September 29, 2008

UN#08-037

Subject: UniStar Nuclear Energy, NRC Docket No. 52-016
Submittal of Response to Requests for Additional Information for the
Calvert Cliffs Nuclear Power Plant, Unit 3 – Supplemental Aquatic RAIs

ITEM NUMBER 1 SUPPLEMENTAL REQUEST REGARDING RAI #12

**FIGURE 3A
 SITE PLAN @ UNIT 3 INTAKE
 STRUCTURE - SHT 2**

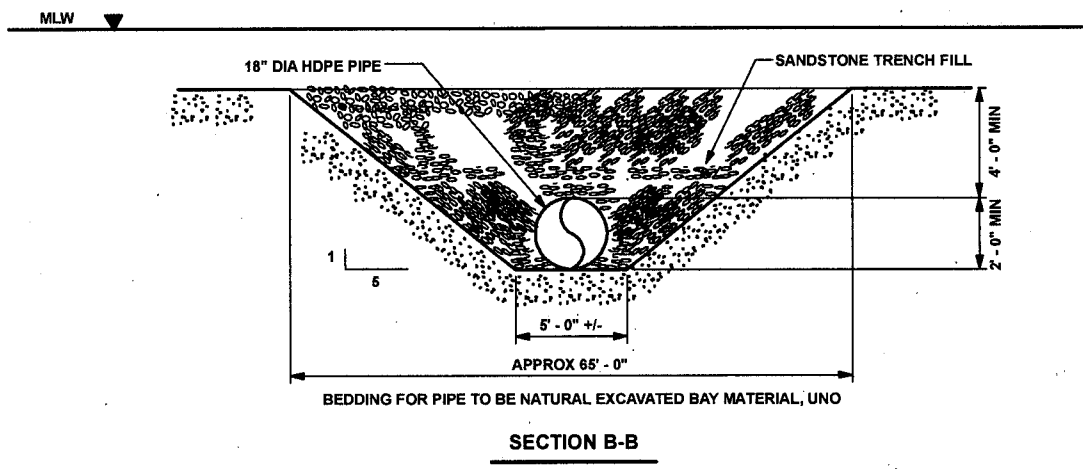
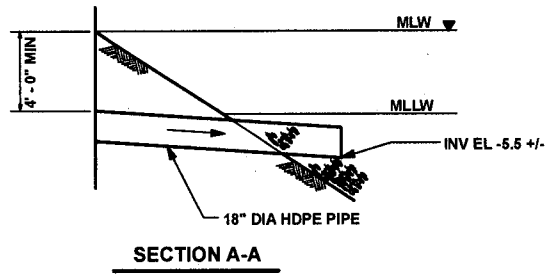
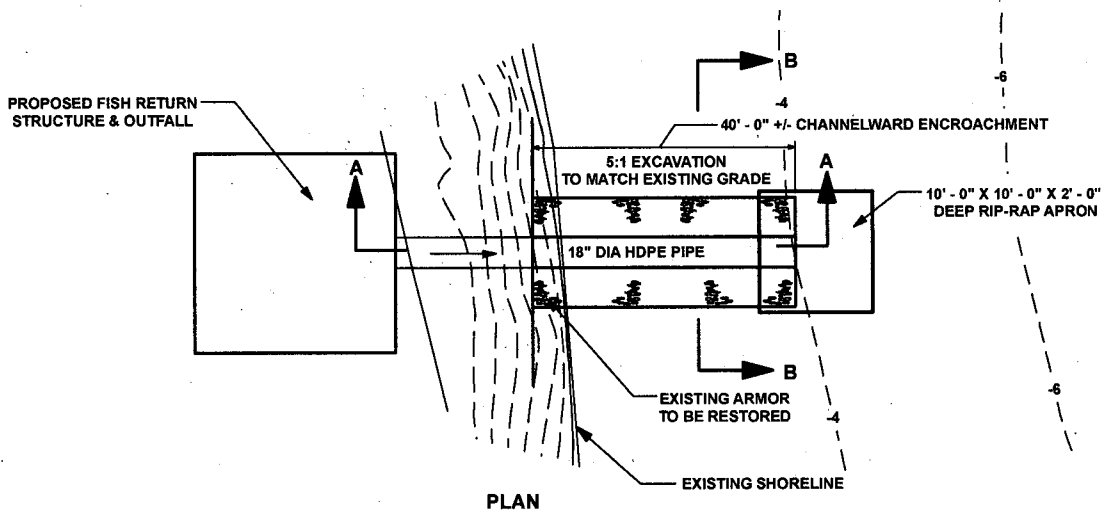
- RAI #58 states (and RAI #63 repeats) that dredging will occur “within the existing CWIS embayment behind the baffle wall...” However, SERR Sections 3.4 and 3.7 state that an expansion of the existing CWIS will be dredged. Please provide the specific locations where dredging will occur. Also, provide information about dredging that will occur during construction of the intake system: the area (size and location) to be dredged? the current water depth in the area to be dredged? To what depth will it be dredged? How much material will be removed? Where will it be disposed? Will there be any armoring at the new intake structure? If so, what is the extent (i.e., length and basal width) of the armored section to be added?

- RAI #58 states (and RAI #63 repeats) that about 15,000 cubic yards of material will be removed to enlarge the barge slip. However, SERR section 3.9.2 states that 60,000 cubic yards will be removed. What is the correct amount of material anticipated to be dredged?

- RAI #58 states (but RAI #63 does not state) that pilings may be driven to support the pipeline installation. Will pilings be driven in Chesapeake Bay to support the pipeline installation? If so, what type of pilings will be used and how will they be installed? If wood pilings are used, will they be treated (what type)? If barges will be used for pile driving, how will they be positioned (e.g., anchors, jack-up supports)? If pile driving will occur, the response to RAI #62 needs to be revisited.

To construct the new Unit 3 intake, will require installing a sheet pile wall extending approximately 180 linear feet from the existing shoreline to existing baffle wall and extending approximately 90 feet channelward of the approximate mean high water shoreline creating an approximately 9,000 square foot wedged shaped pool. To install the new sheet pile wall, approximately 50 feet of existing shoreline armor protection will be removed. Once the new sheet pile wall is in place, approximately 60-feet of armor within the wedged shape pool will be removed and temporary upland sheet piling will be installed along the make up water pipe routing. This upland sheet piling will extend out into the wedge shaped pool approximately 30 feet to facilitate dewatering, installation of the pipe and the associated trash rack. The area within the wedged shaped pool surrounded by the sheet piling will be dewatered and dredged by mechanical method to create an approximately 30-foot wide by 30-feet long by 25-feet deep area, resulting in approximately 900 cubic yards of sand and gravel, which will be deposited at an existing upland (non-wetland), environmentally controlled area at the Lake Davies laydown area onsite. Existing water depths range from approximately -18 to -24 feet. After dredging, two 60-inch intake pipes with trash racks at the pipe openings, extending approximately 20 feet channelward to a bottom elevation of -25 feet mean low water, will be installed. After installation of the pipes and associated trash racks, shoreline armor protection along the shore approximately 80 linear feet and extending 10 feet channelward will be restored within the wedged shaped area. In addition, armor protection will extend out beyond the new sheet pile wall approximately 75 linear feet and extend approximately 205 feet channelward. As a final step, the temporary sheet pile wall, around the 60-inch intake pipes will be removed allowing the area to flood and submerge the pipes (attached Figure 3A).

**FIGURE 5B
 SEAL WELL &
 DISCHARGE PIPING**

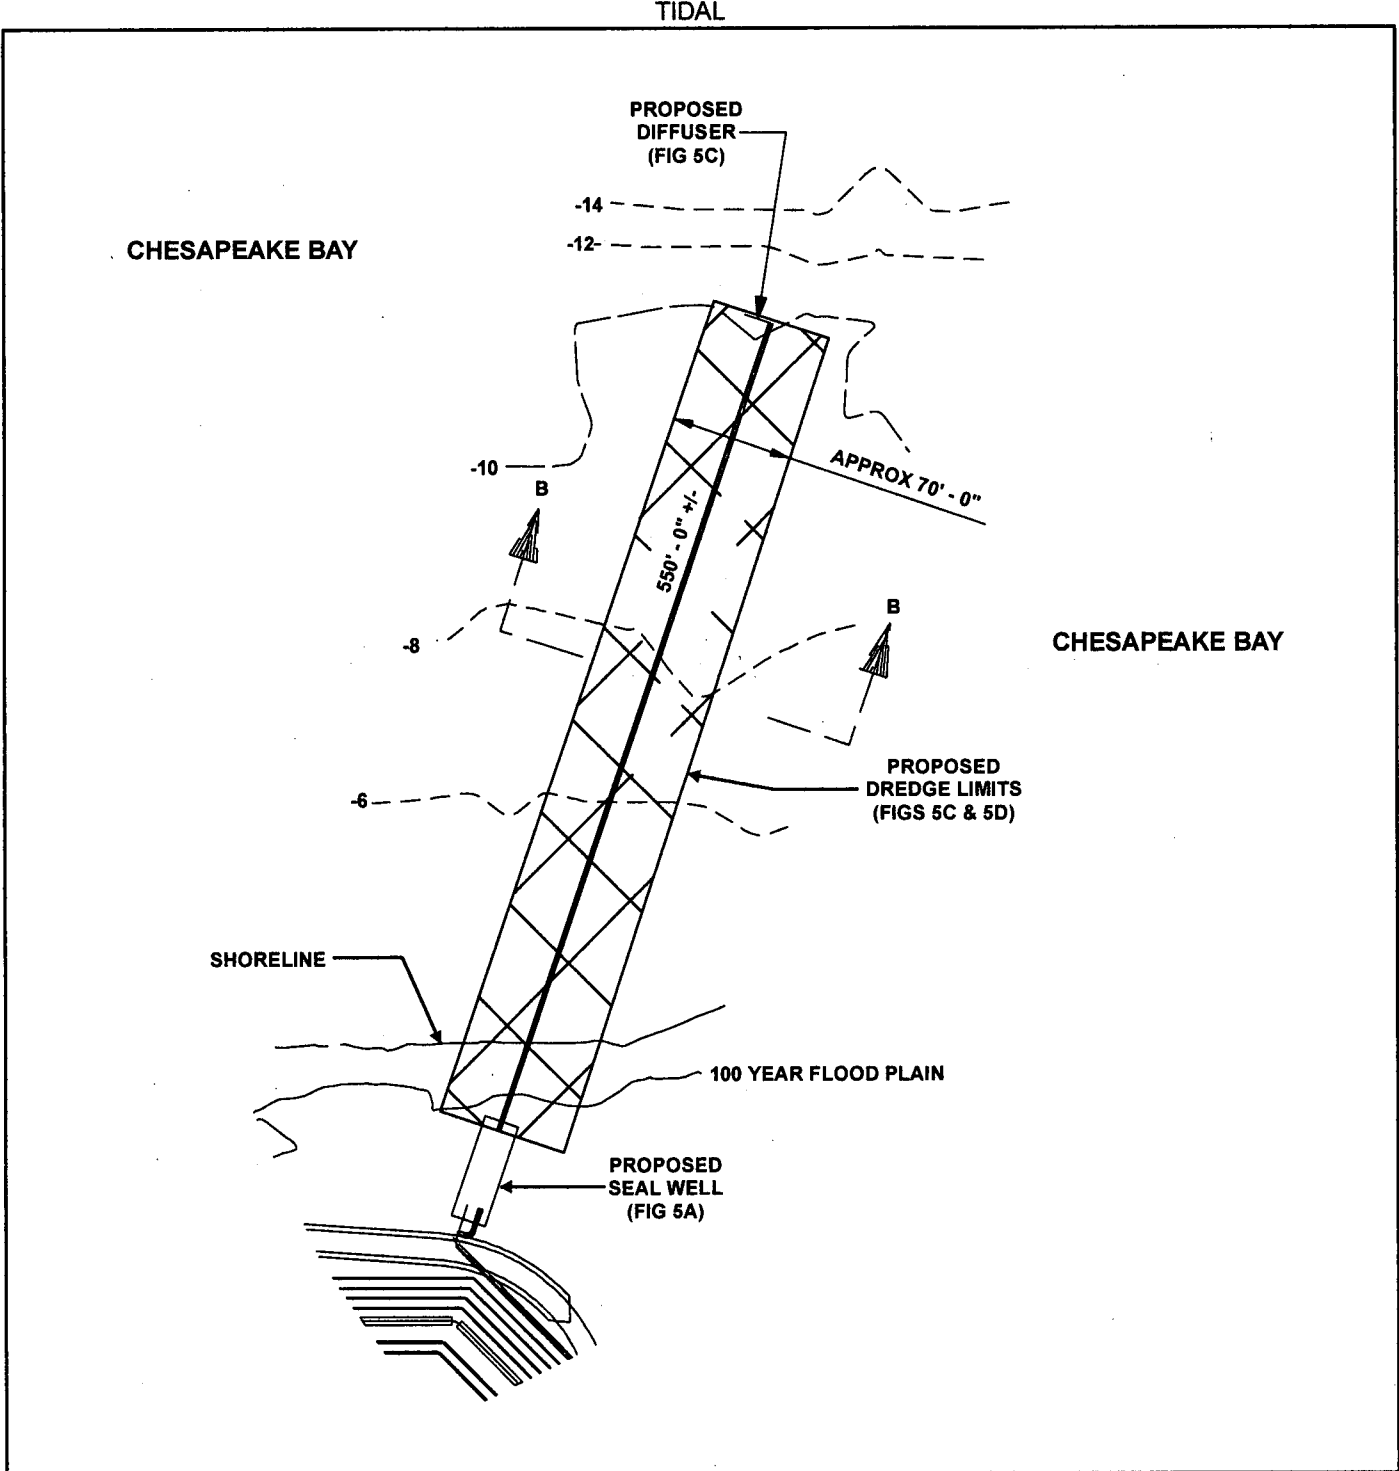
RAI #61 requested information about the discharge pipeline installation. The response provides some of the physical dimensions of the pipe and diffuser system. Please provide specific information about the pipeline installation.

- The response states that the trench will be limited to that needed to install the pipe, but doesn't give any details. How wide will the trench be dredged? How much material will be removed? Where will it be disposed?
- The response states that riprap or stone will be used to cover the pipe. What size and type of rock (riprap) will be used to cover the outfall pipe and to protect the diffuser? To what width around the pipe and diffuser will the rock be placed? How far above sediment grade will the riprap extend? Figure 3.8-3 of the Supp. ER appears to show that the top of the pipe will be about 4 ft beneath the bay bottom, but shows that the pipe will be covered with riprap and filter. What is "filter"? [typo for filler?] The figure also suggests that part of the trench may be filled with material other than riprap. If so, what is that material and what is its source?

The trench to be dredged for the discharge pipe installation will be 550 feet in length. The trench will be dredged in a trapezoidal form at a 5:1 side slope to prevent sloughing of the trench sides. The actual trench bottom width will range from 3 to 6 feet wide. Maximum width of the trench top will be approximately 70 feet wide (attached Figures 5B, 5C, and 5D). Approximately 7,000 cubic yards of material will be dredged for the pipe installation. Of the 7,000 cubic yards, approximately 5,800 cubic yards will be used to backfill the trench with the remaining approximately 1,200 cubic yards will be deposited at an existing upland (non-wetland), environmentally controlled area at the Lake Davies laydown area onsite.

The trench will be back filled with the material dredge from the bay bottom for the discharge pipe trench. $D_{50}=12$ riprap and filter fabric will be placed on top of the back filled material for a minimum of 4 feet of cover over the discharge pipe (attached Figure 5D). The riprap will be placed within discharge pipe trench to the top of the trench at the original grade of the bay bottom. This riprap will not extend above the existing bay bottom topography. The riprap will extend approximately 10 feet on each side of the diffuser.
